REQUEST

Current Zoning: R-22MF(CD) (multi-family residential)
Proposed Zoning: UR-2(CD) (urban residential, conditional)

The petition proposes to develop a vacant site located in the Tryon Hills neighborhood with up to 323 residential dwelling units consisting of single family detached, single family attached, and multi-family residential dwellings, at a density of 29.3 units per acre.

• **Proposed Request Details**

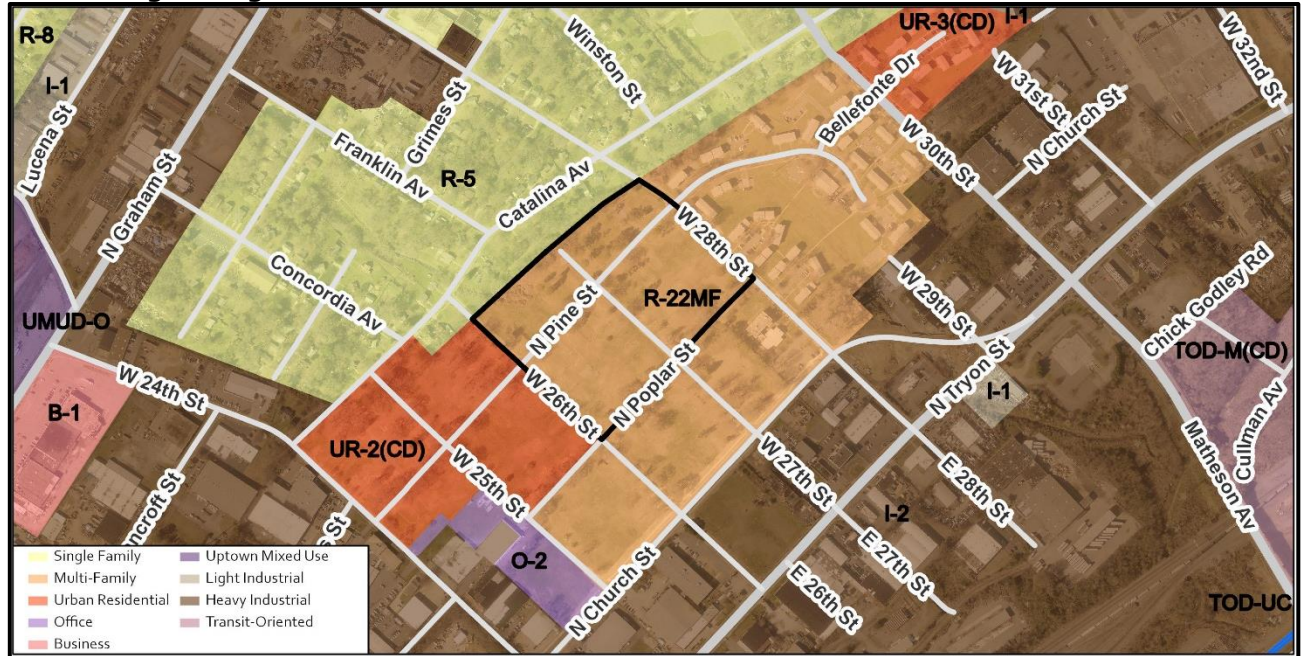
- ~~1. Add a conditional note that recessed on-street parking will be provided along all street frontages in accordance with CLDSM.~~ Addressed
- ~~2. On sheets RZ-1 and RZ-2, remove call-out to abandon and remove W. 27th Street. Also, remove the site conditional note 3. Access, Buffers, Screening, Open Space and Pedestrian Circulation.~~

~~Note I. The abandonment of W. 27th Street is not consistent with the USDG Standards.~~

3. ~~Remove note 3.K. This is covered in the site plan call out and is a separate process from the rezoning.~~ Addressed

4. Clarify site plan note 3b. that the 3-foot wall is in addition to parking lot screening per section 12.303. Wall does not satisfy the requirement on its own. Outstanding
5. ~~Clarify site plan note 2i. to state how frequently the modulation will occur.~~ Addressed

Addressed
